Addendum D2

re: **City of Berne**
New Municipal Maintenance Building
335003.00

date: **February 16, 2024**

ADDENDUM NO. 2
To the Contract Document for the

SD104

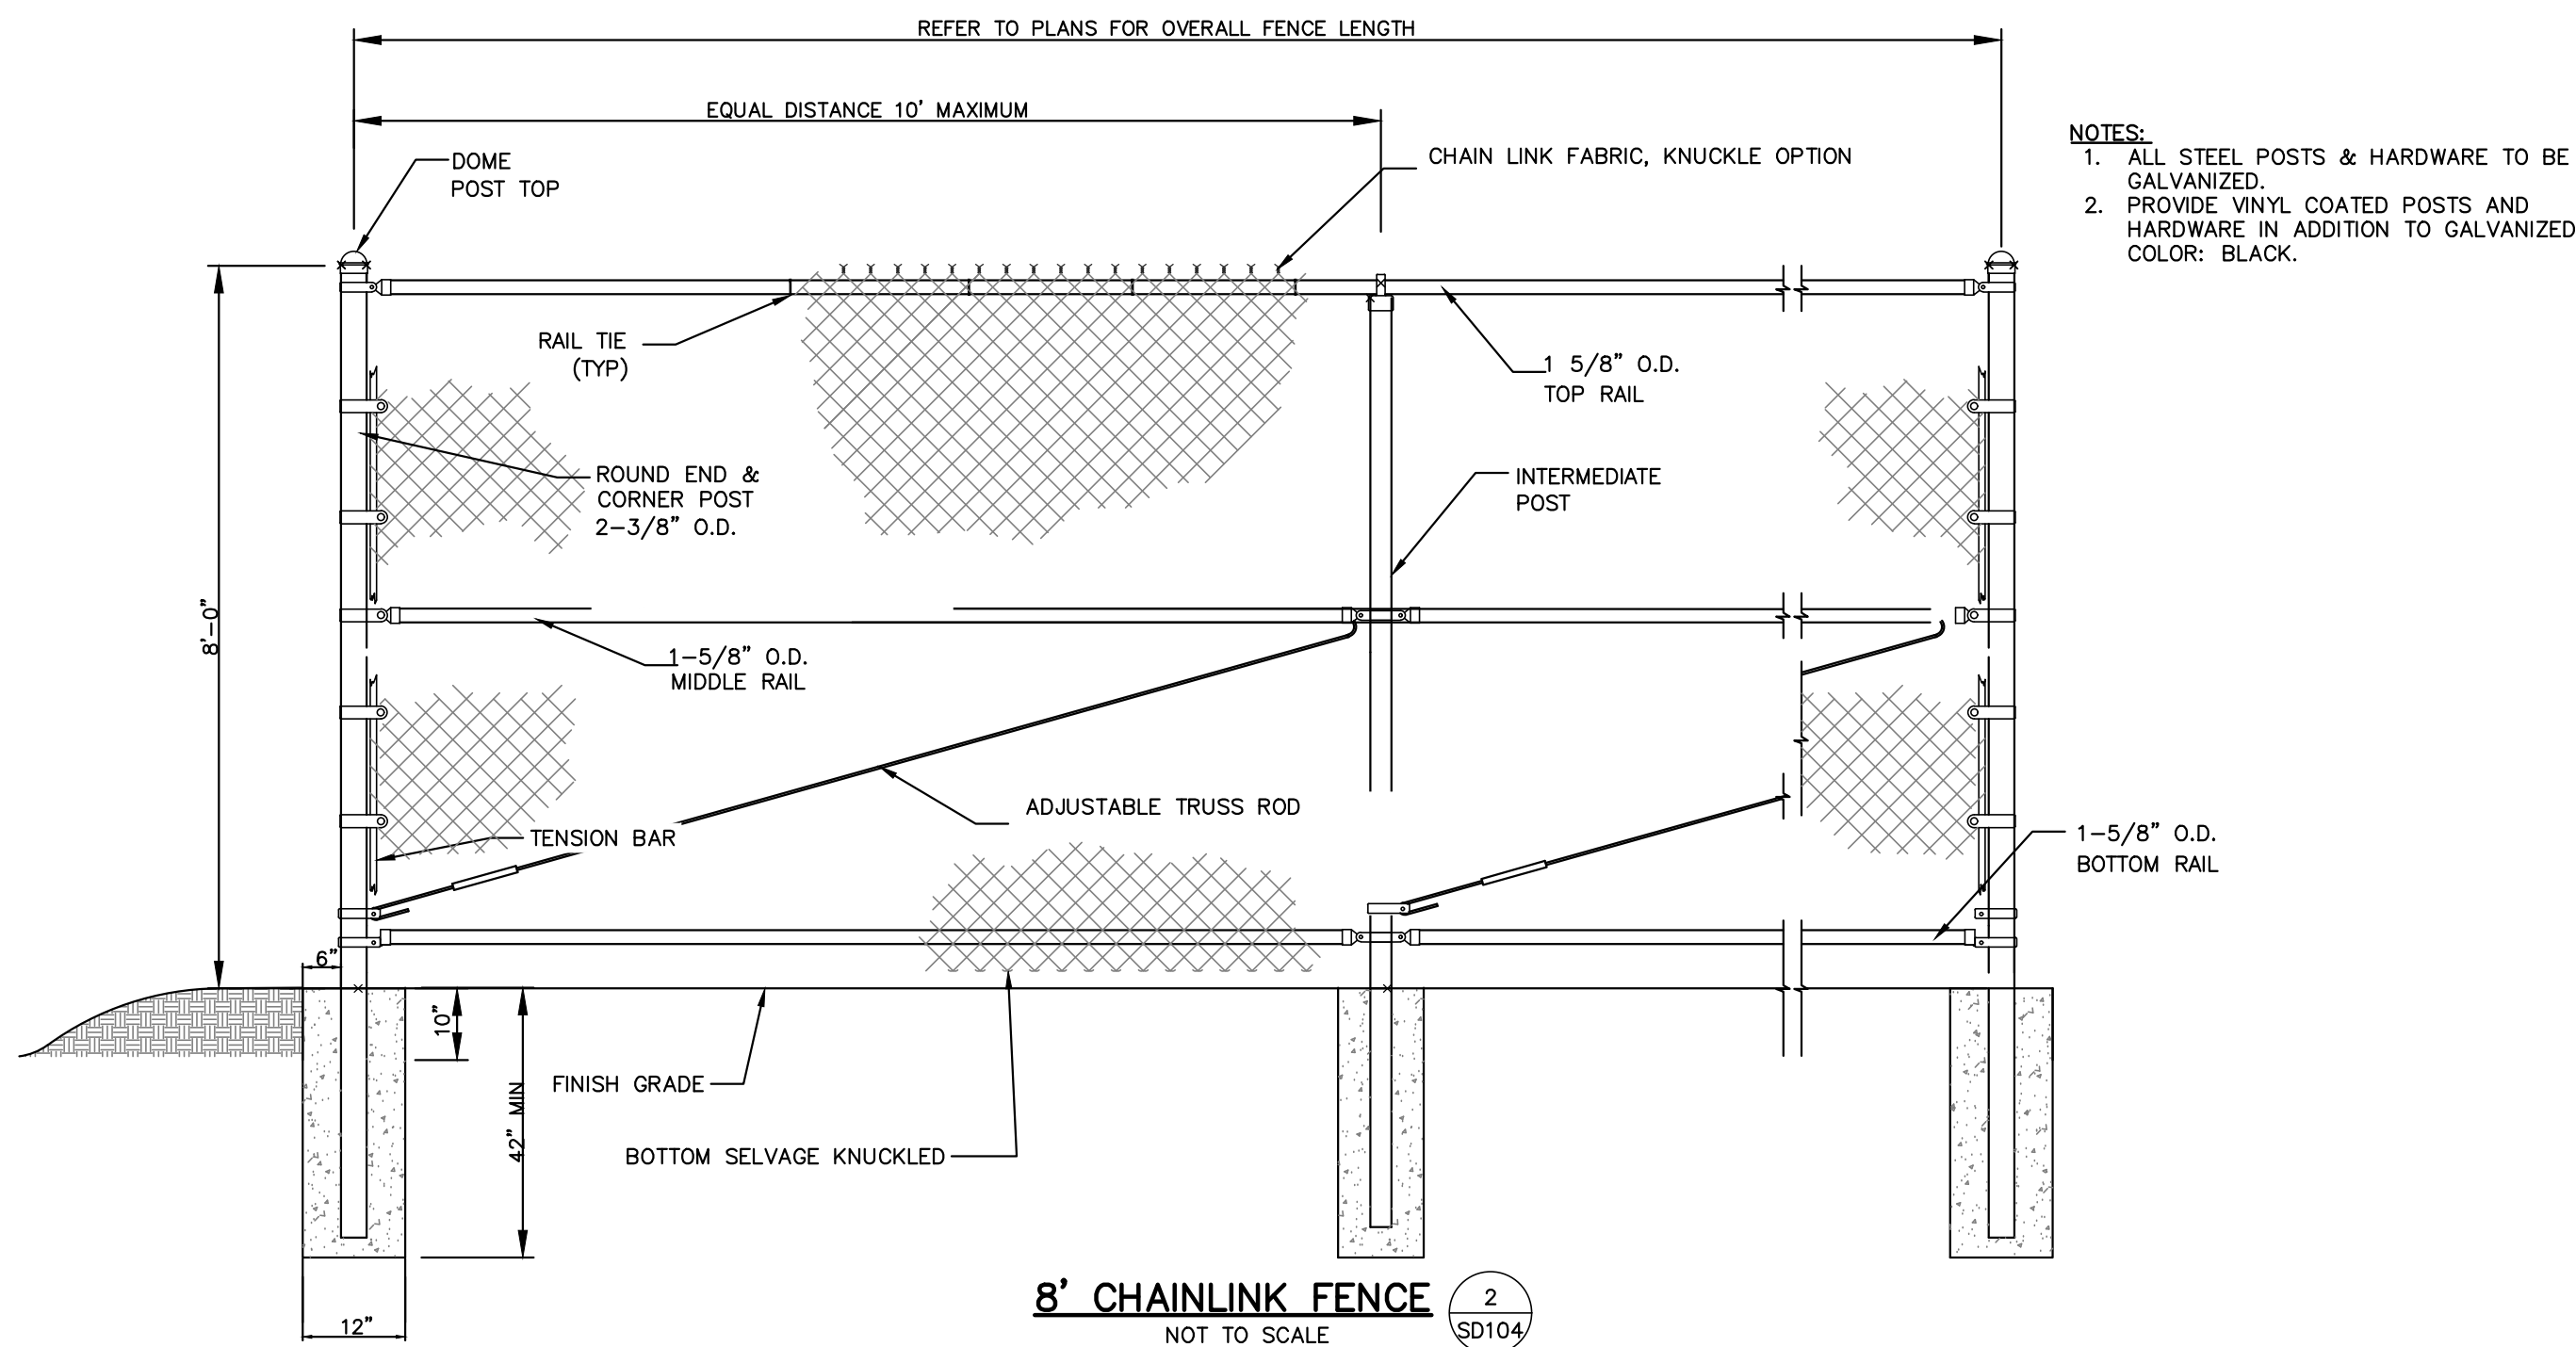
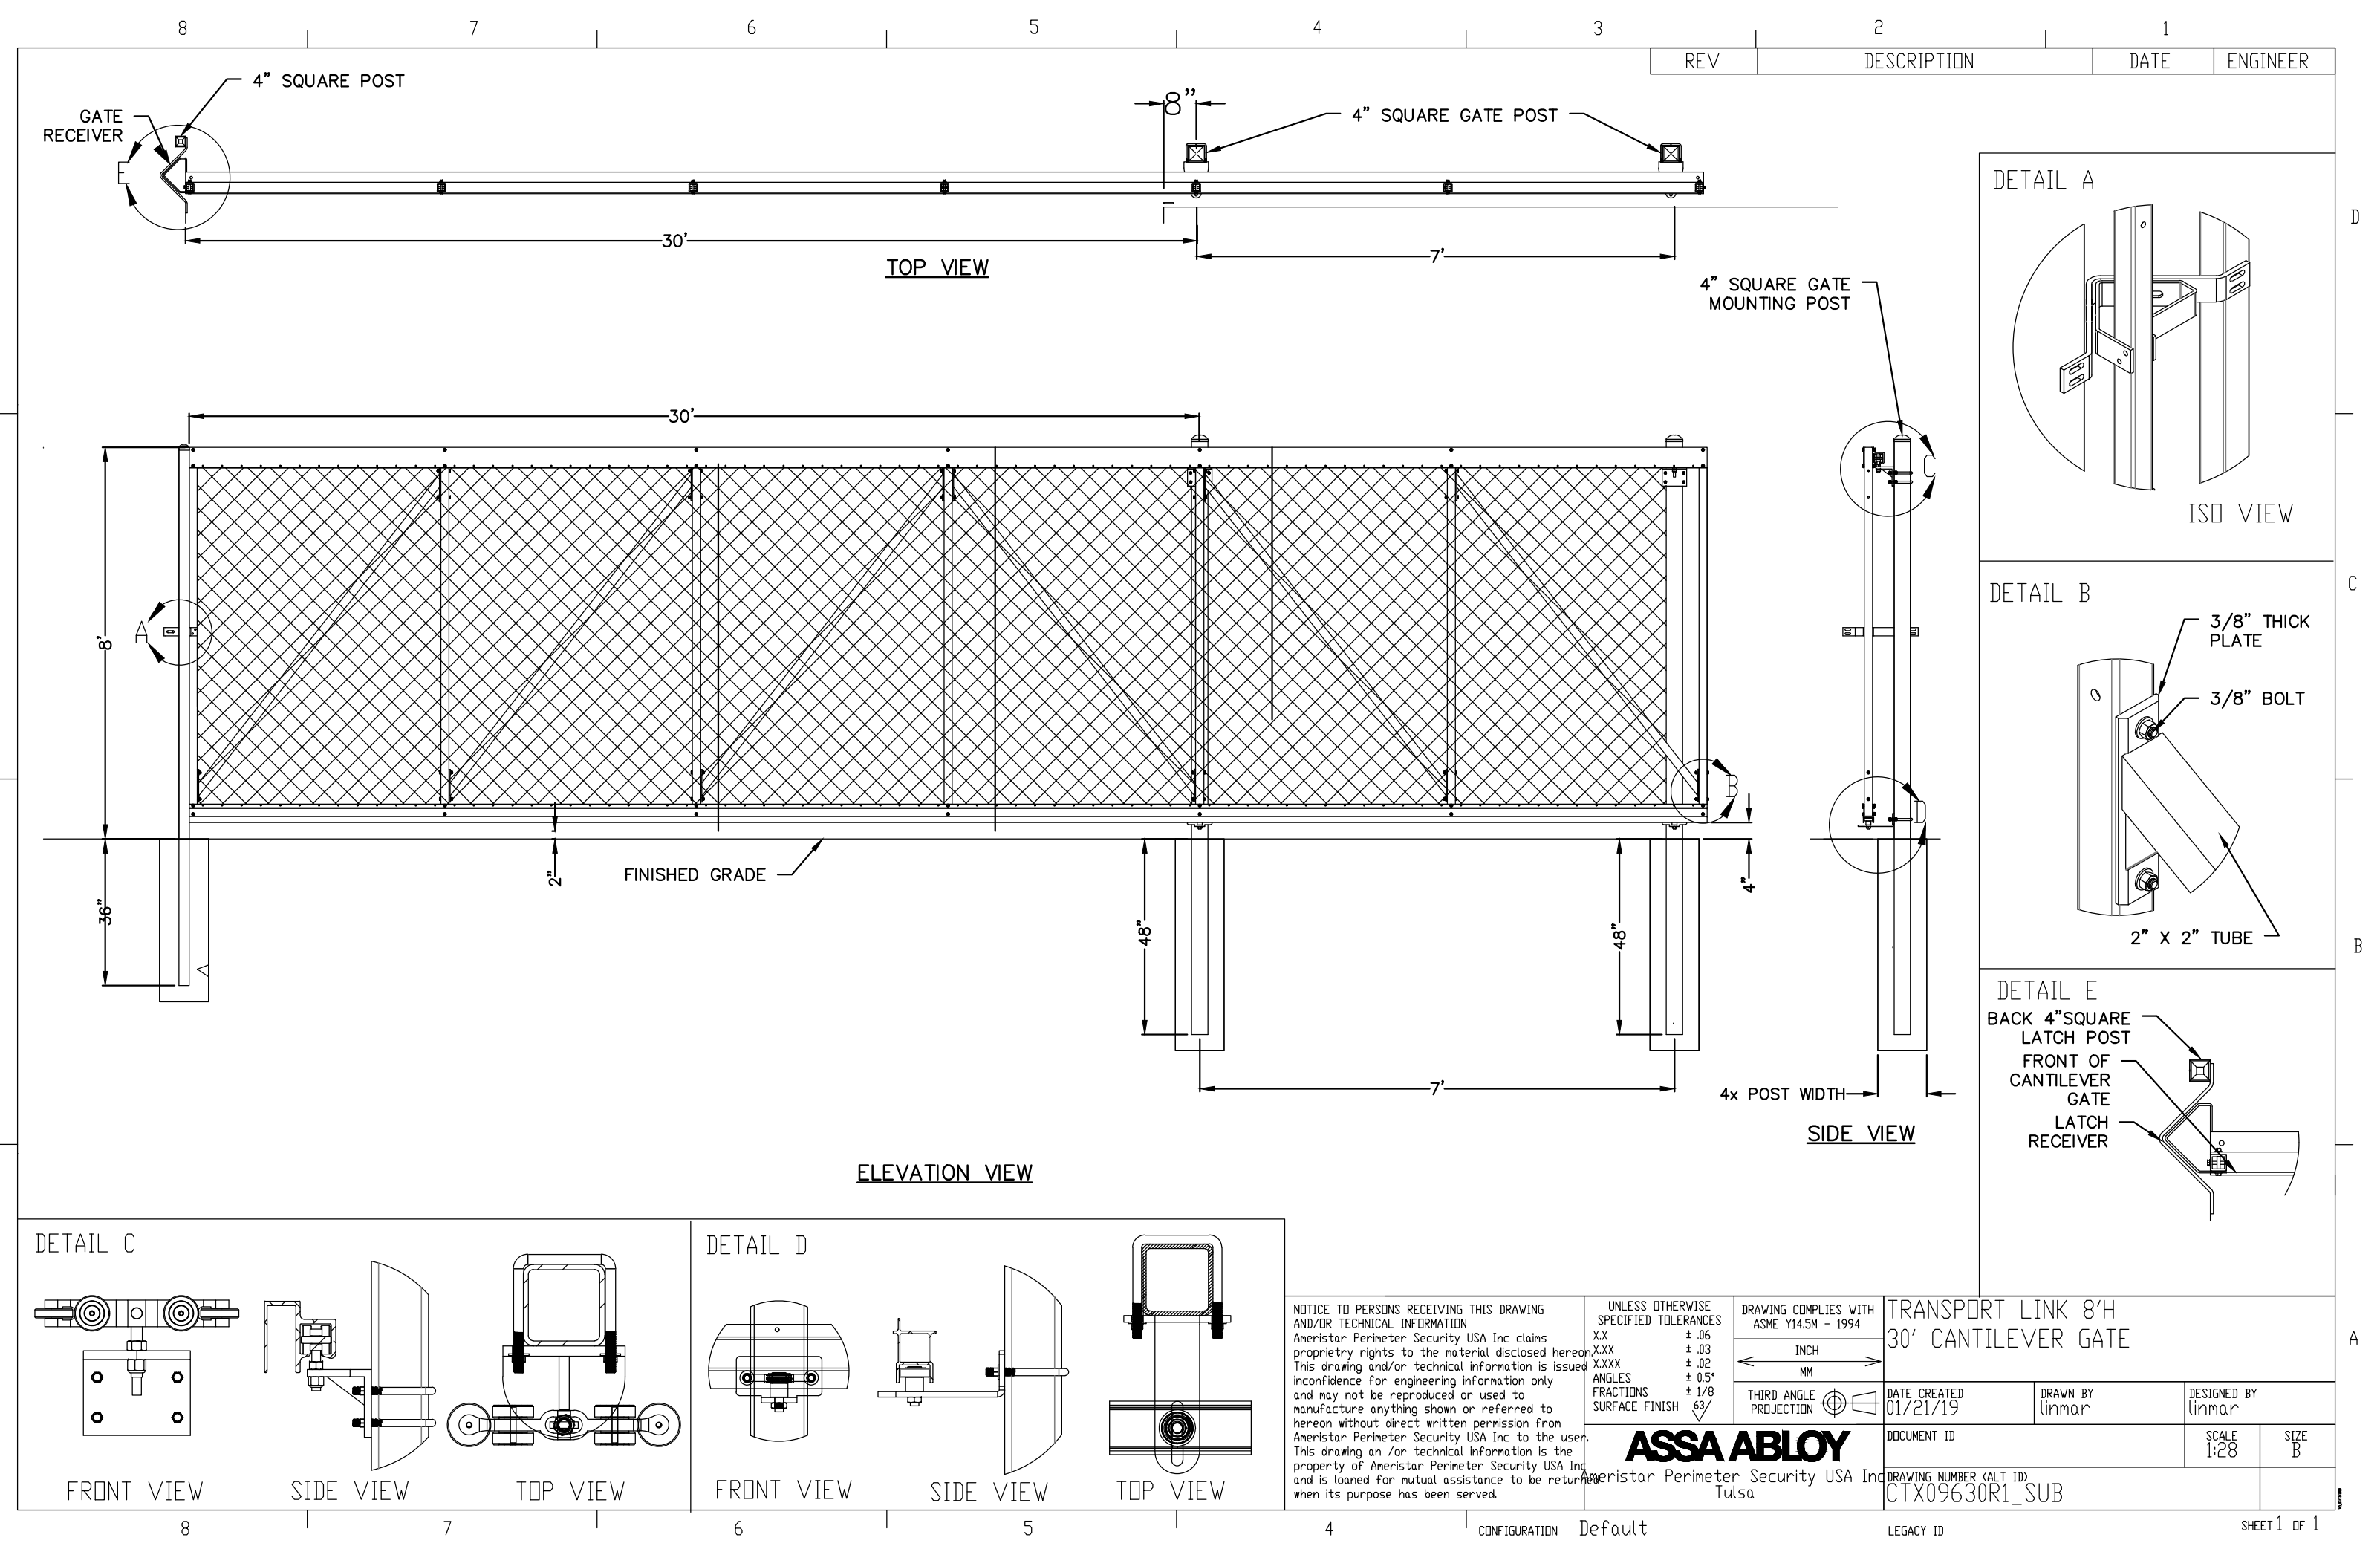
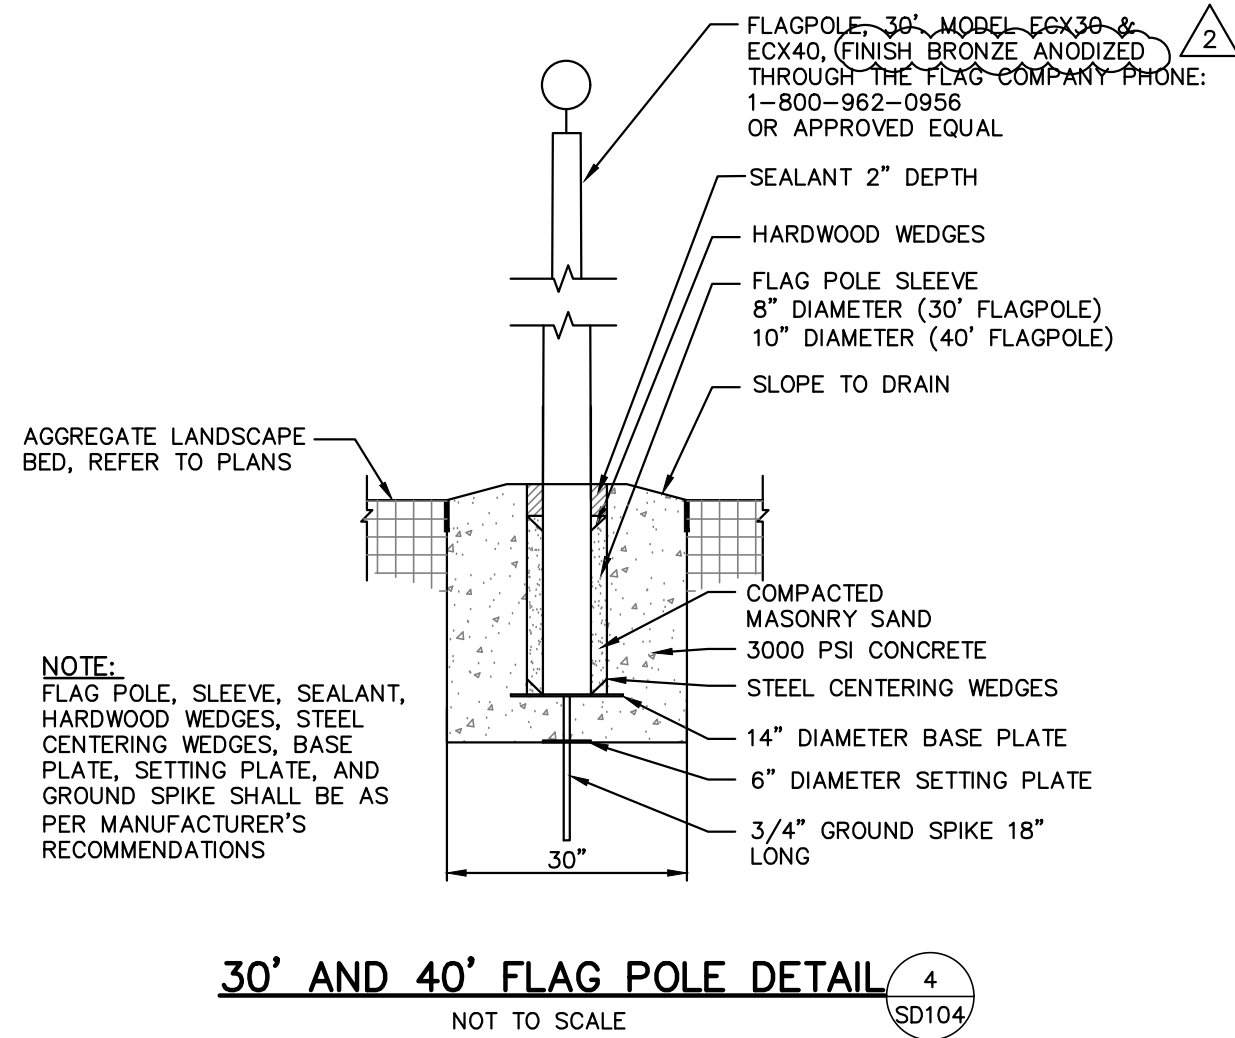
9. Plan Sheet SD104:
 - A. **REVISE** Detail 4 to include a finish of bronze anodized.

1. This project has a 30' and 40' flag pole and the only place we can find this referenced is the civil plan directs you to detail 4/SD104. This provides the model of each, but there are several different finishes for each model. Can you clarify the finishes for the flag poles please.

RESPONSE: Plan sheet SD104 Detail 4 has been updated to include the finish of bronze anodized for the flag poles.
